FORM APPROVED
OMB No. 1004-0137
Expires: July 31, 2010**SUNDRY NOTICES AND REPORTS ON WELL COMPLETION**
Do not use this form for proposals to drill or to re-enter an abandoned well. Use Form 3160-3 (APD) for such proposals.5. Lease Serial No.
NMNM 1129536. If Indian, Allottee or Tribe Name
Farmington Field Office**SUBMIT IN TRIPLICATE – Other instructions on page 2.**

Encana Oil & Gas (USA) Inc. (Encana) wishes to submit re-clarification for the intended SHL, POE and BHL footages for the Lybrook E27-2306 03H well prior to the submittal of the Well Completions Sundry, which is dated March 12, 2014. The intended footages should have been as follows:

WELL LOCATION AND ACREAGE DEDICATION PLAT

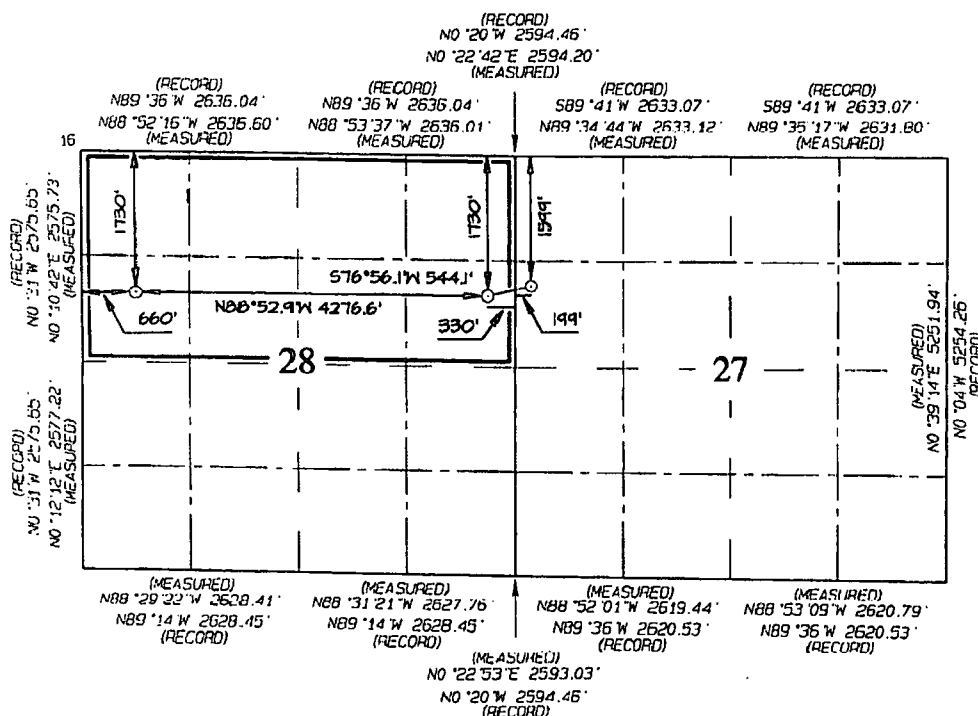
Surface Hole: 1599' FNL, 199' FWL Section 27, T23N R6W
Point of Entry: 1730' FNL, 330' FEL Section 28, T23N R6W
Bottom Hole: 1730' FNL, 660' FWL Section 28, T23N R6W
An executed C-102, dated March 1, 2014 reflecting the above footages is enclosed.

END-OF-LATERAL
1730' FNL 660' FWL
SECTION 28, T23N R6W
LAT: 36.19869°N
LONG: 107.47950°W
DATUM: NAD1927

POINT-OF-ENTRY
1730° FNL 330° FEL
SECTION 28, T23N, R5W
LAT: 36.19861°N
LONG: 107.46501°W
DATUM: NAD1927

SURFACE LOCATION
1599' FNL 199' FWL
SECTION 27. T23N, R6W
LAT: 36.19897°N
LONG: 107.46322°W
DATUM: NAD1927
